DOCUMENT 00 90 00
ADDENDUM

ADDENDUM No.: 3

RE: LAC DU FLAMBEAU CHILD DAYCARE CENTER
ADJACENT TO 13708 YOUTH CTR LN (TO THE SOUTH)
LAC DU FLAMBEAU, WISCONSIN 54538
PROJECT NO. 22066

Graphic Scale: **VARIES**

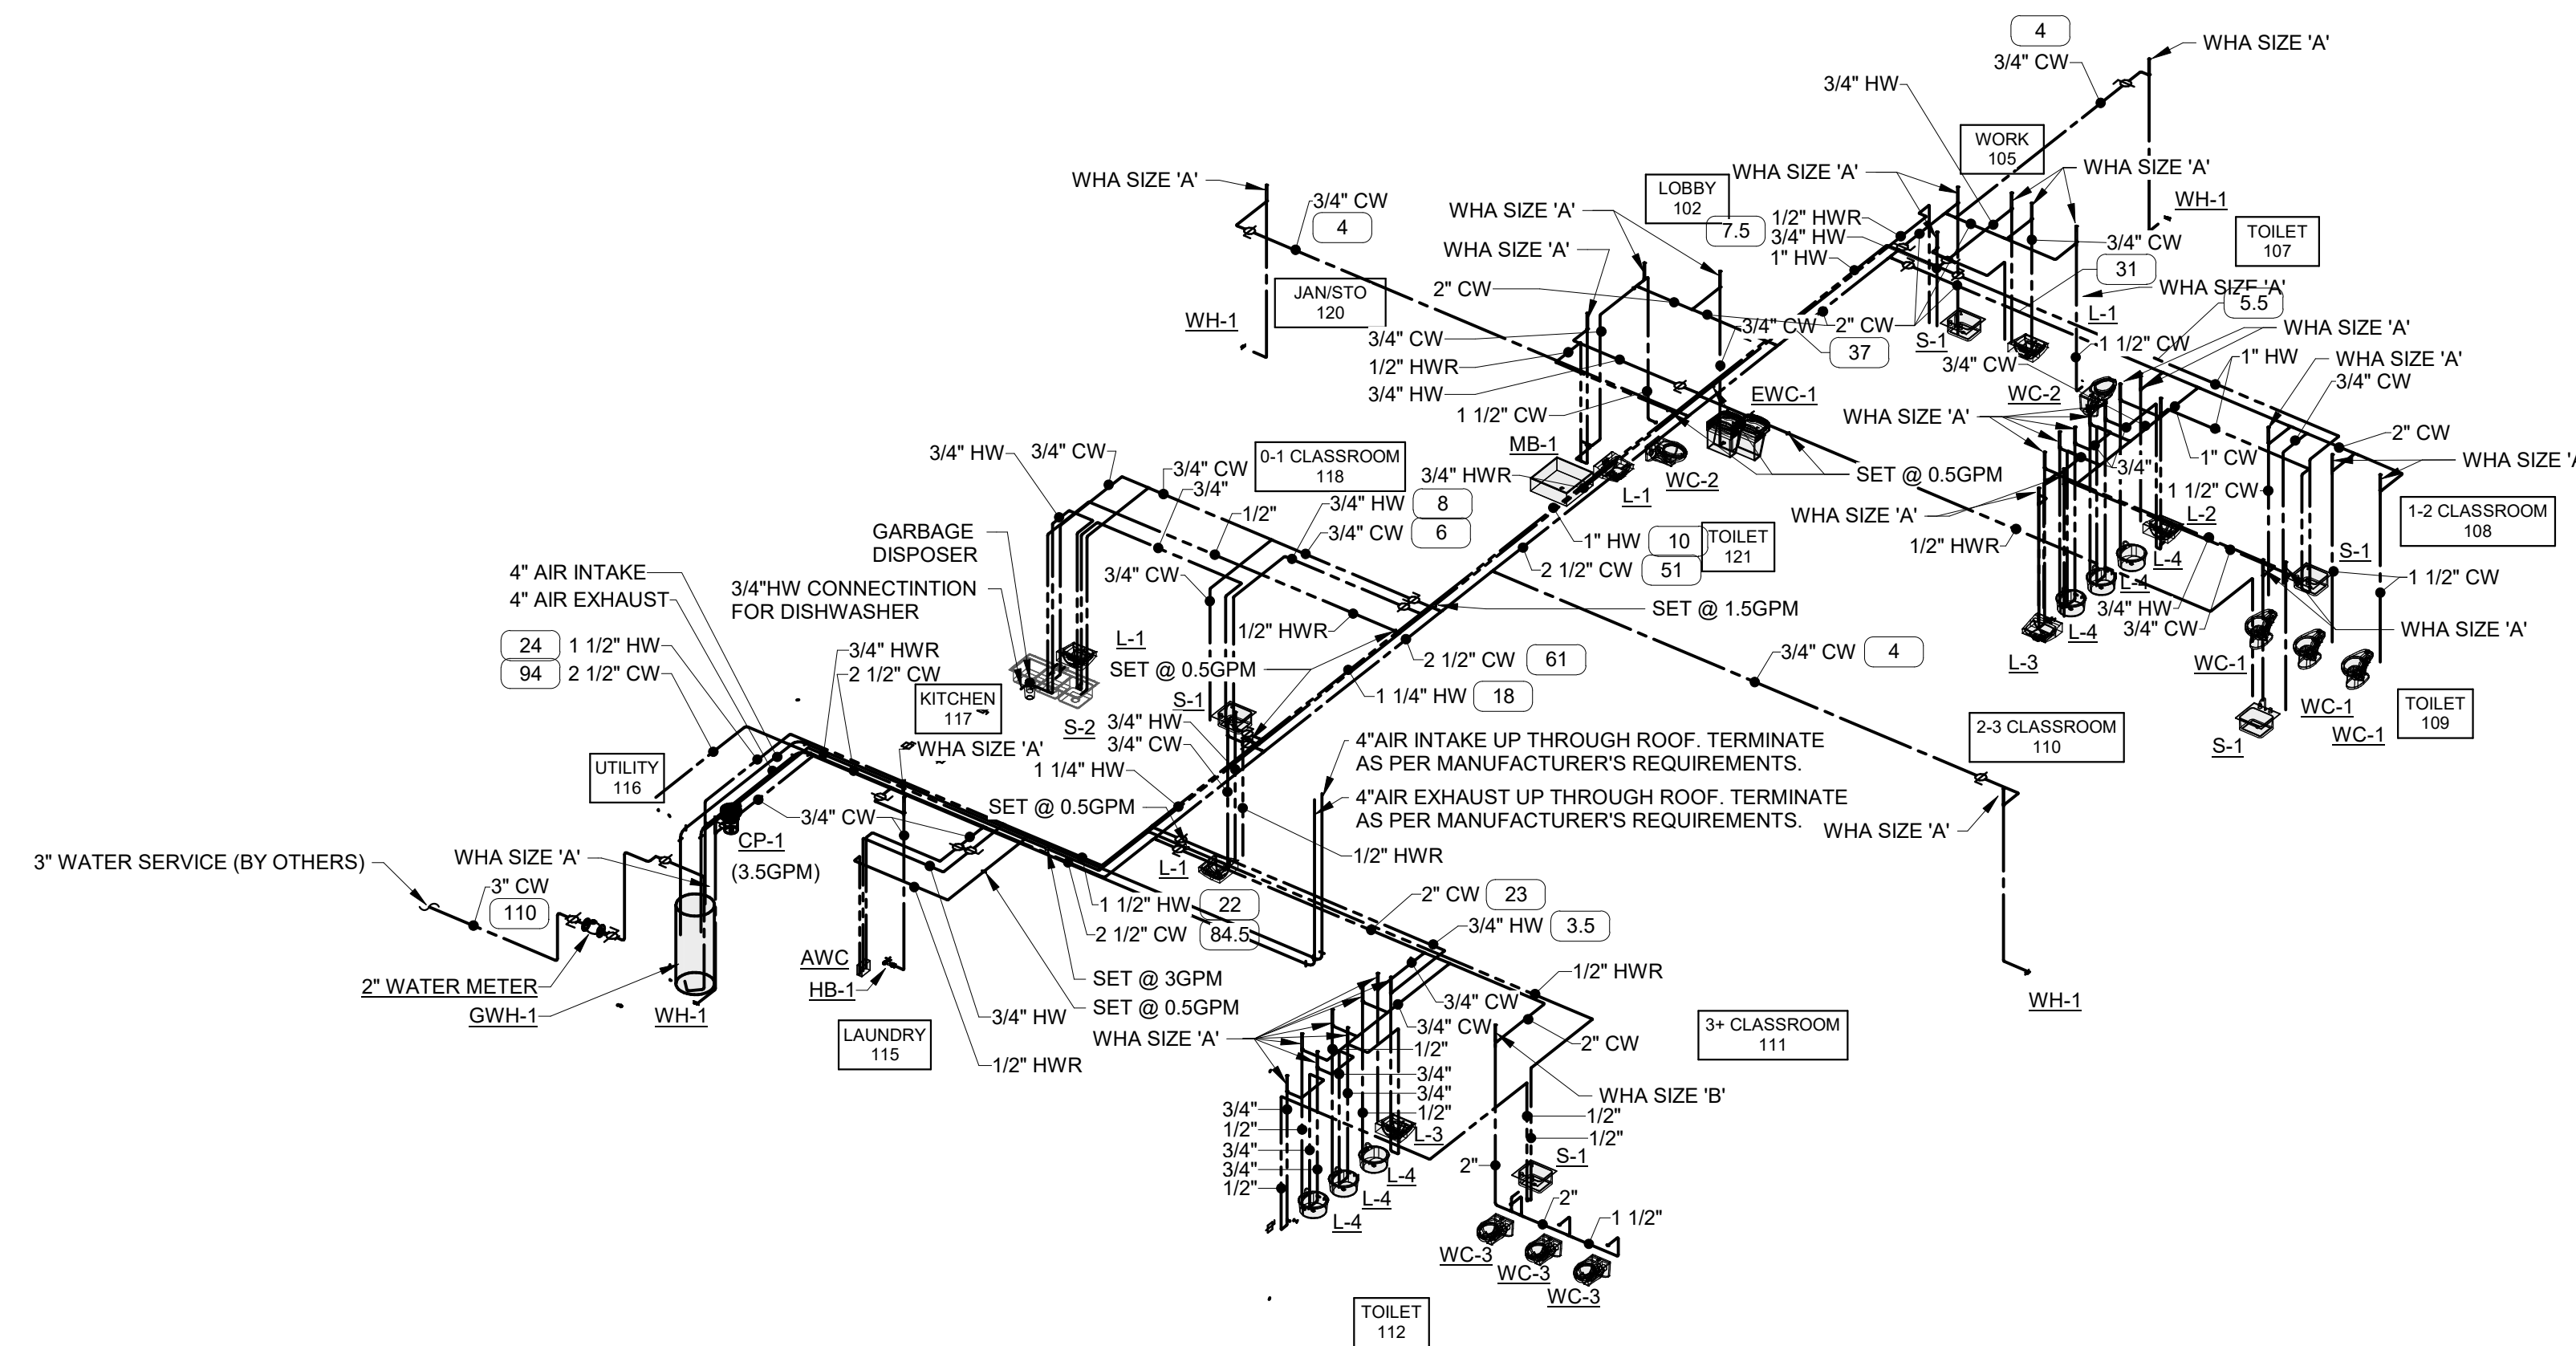
- b. Revised the selections for PLAM and Tile.
12. Sheet P100 FOUNDATION & FIRST FLOOR PLUMBING PLAN 30"x42"
 - a. See the revised sheet included in this addendum. Disregard the previous version.

- b. Added piping associated with an added site LP tank.
13. Sheet P400 PLUMBING RISER DIAGRAMS 30"x42"
 - a. See the revised sheet included in this addendum. Disregard the previous version.

P400

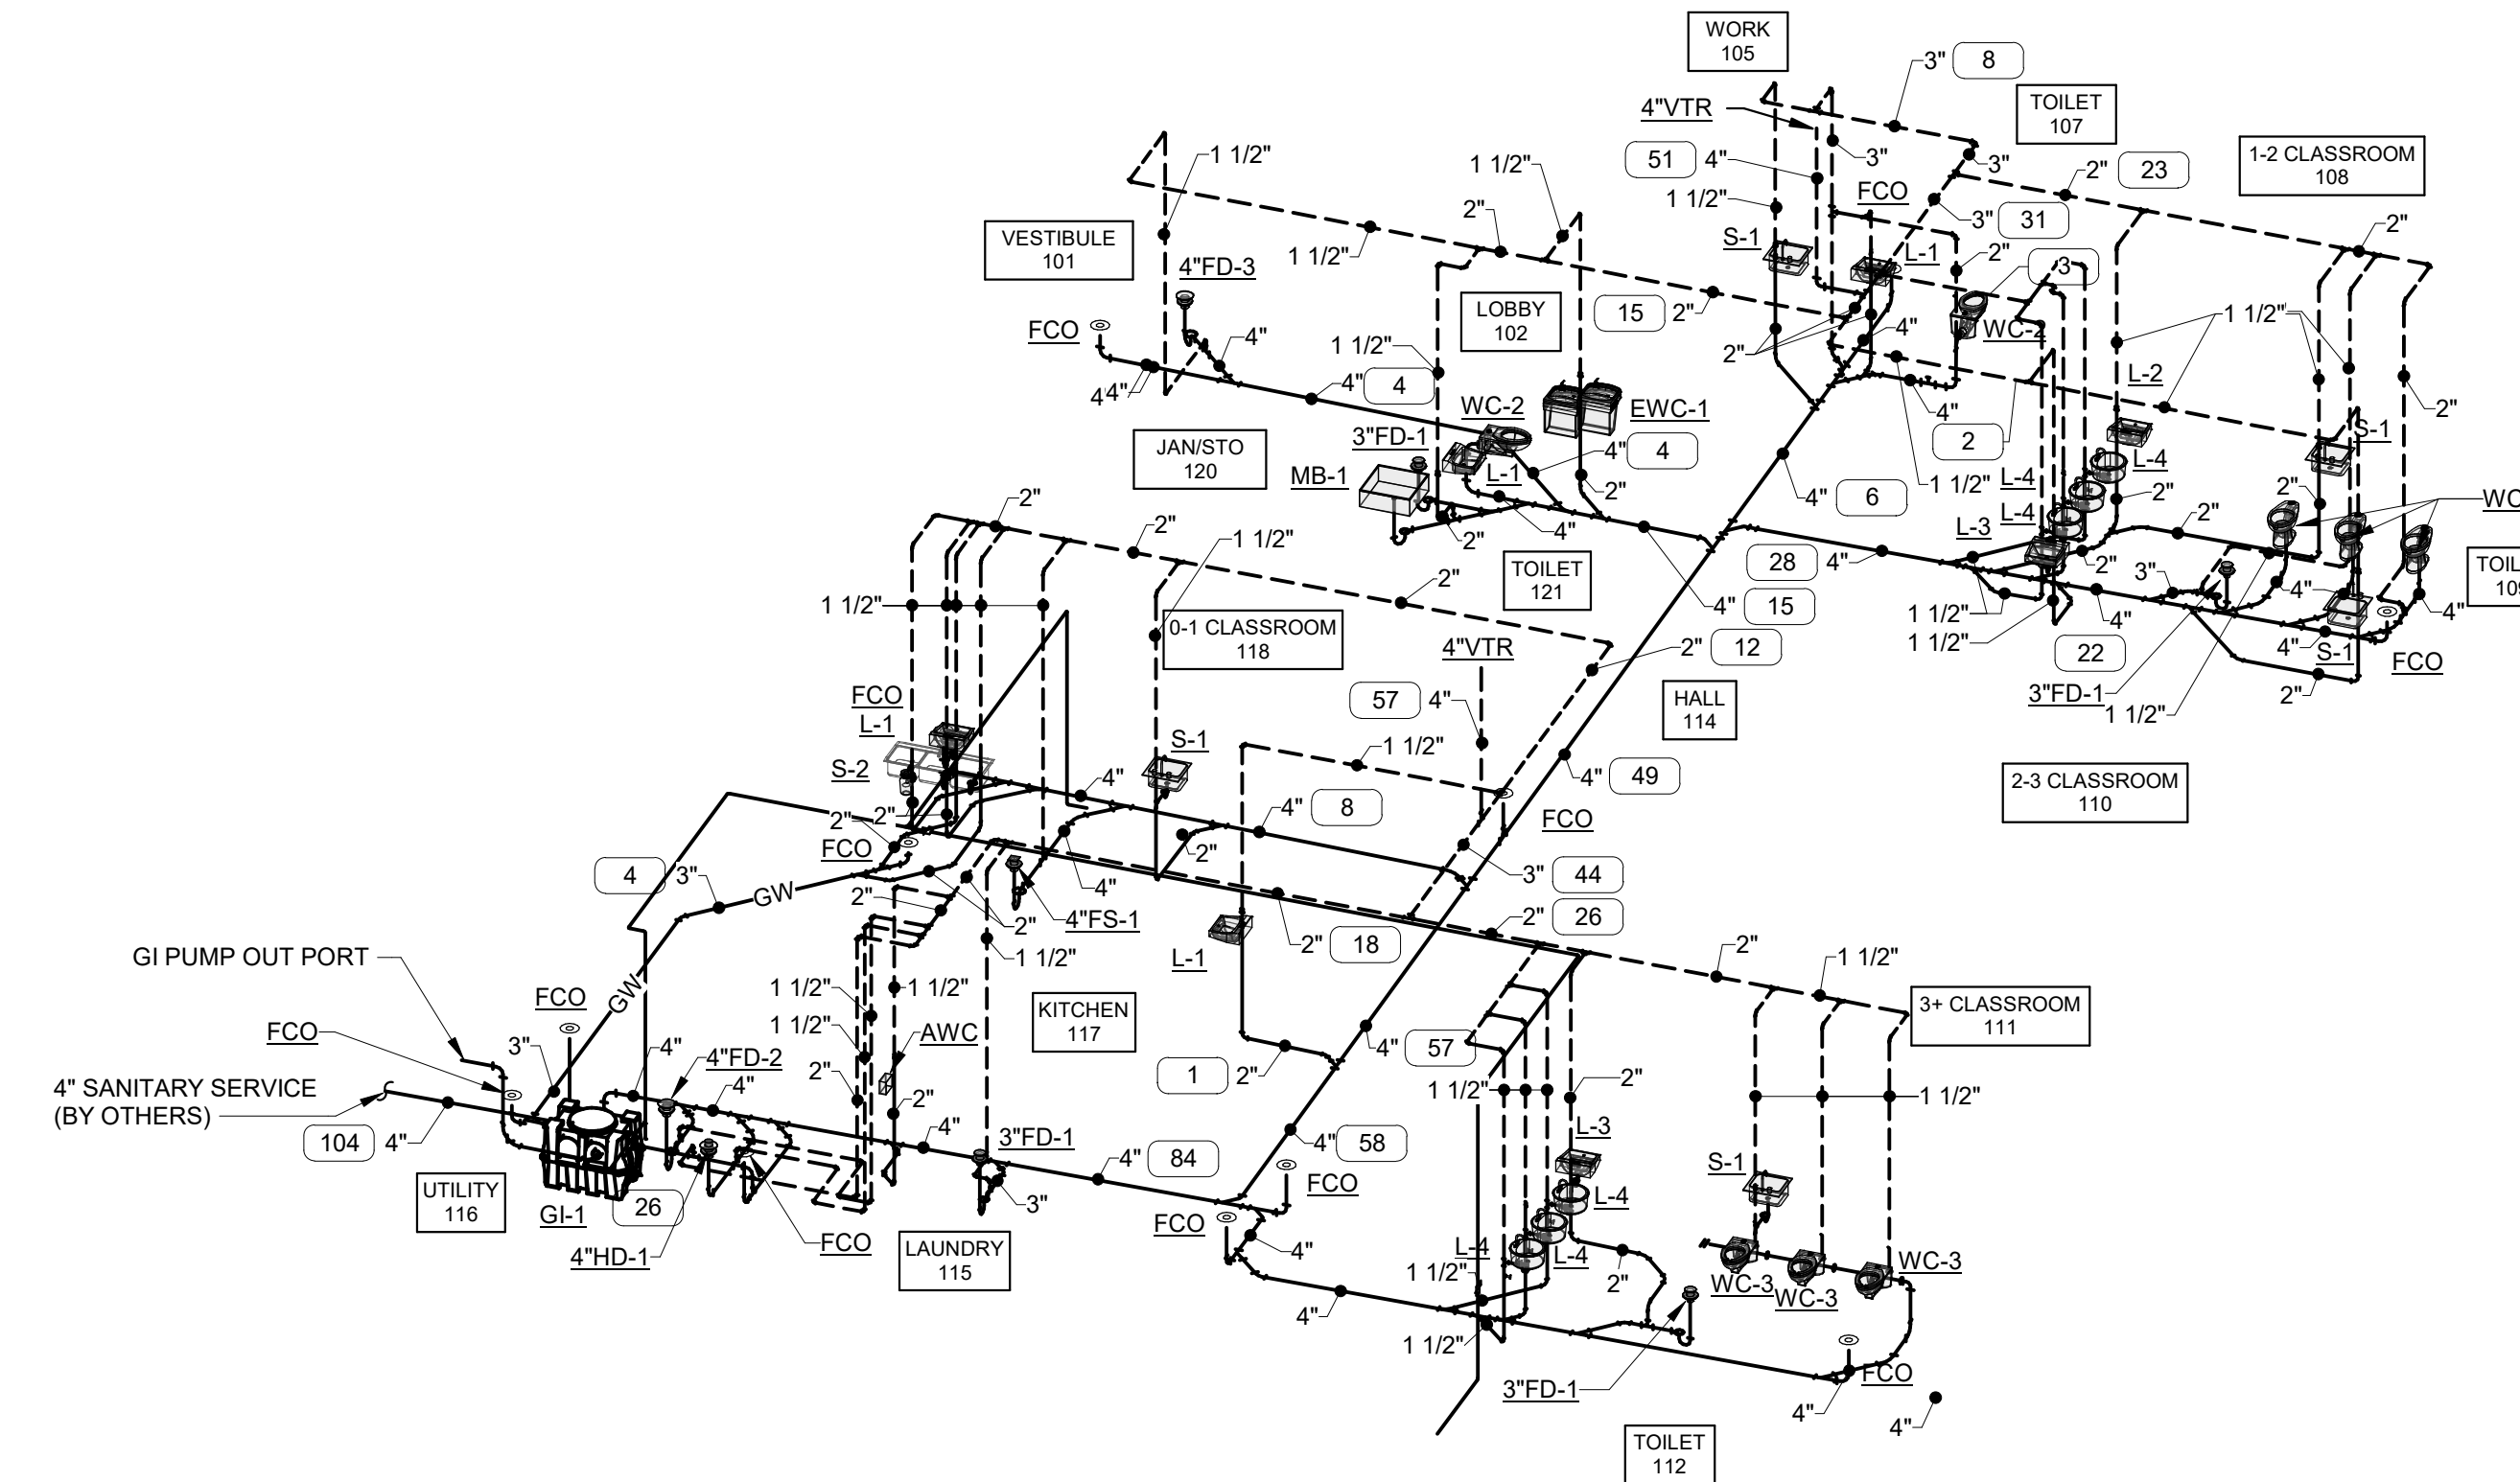
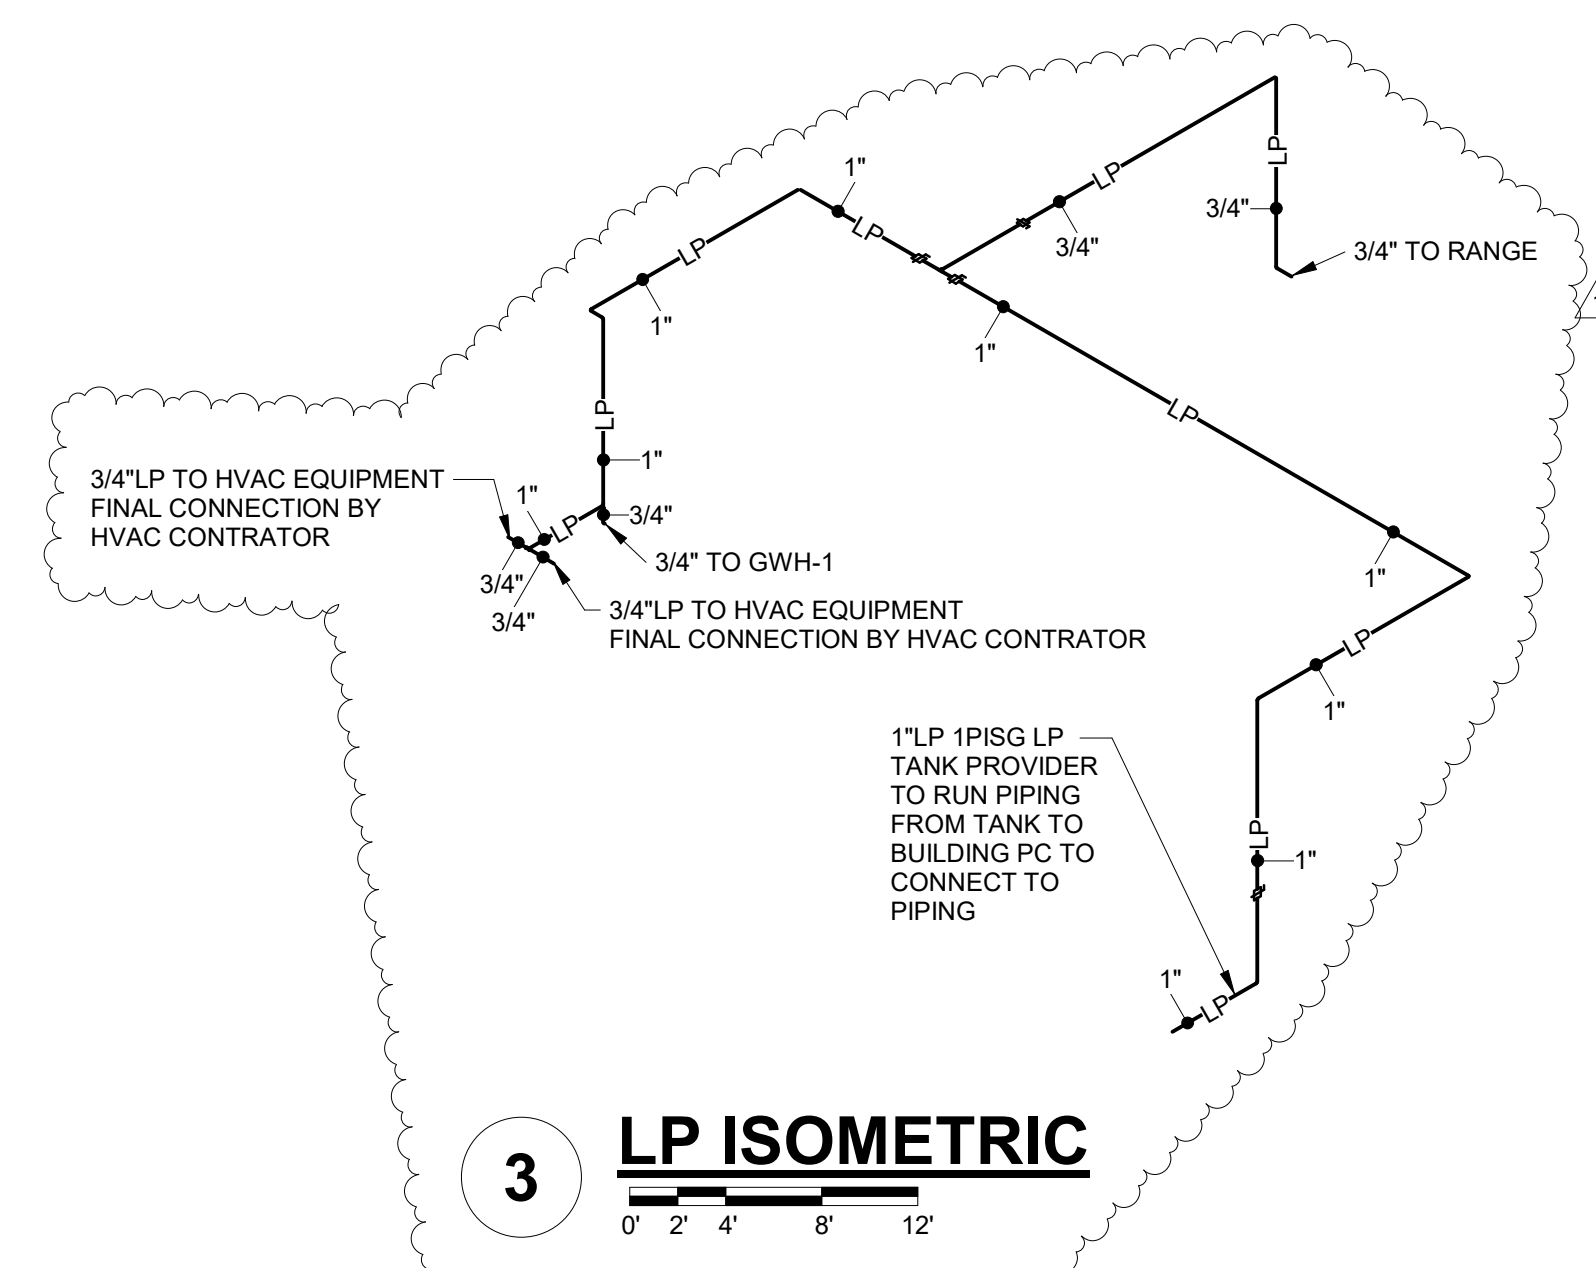
- b. Added piping associated with an added site LP tank.
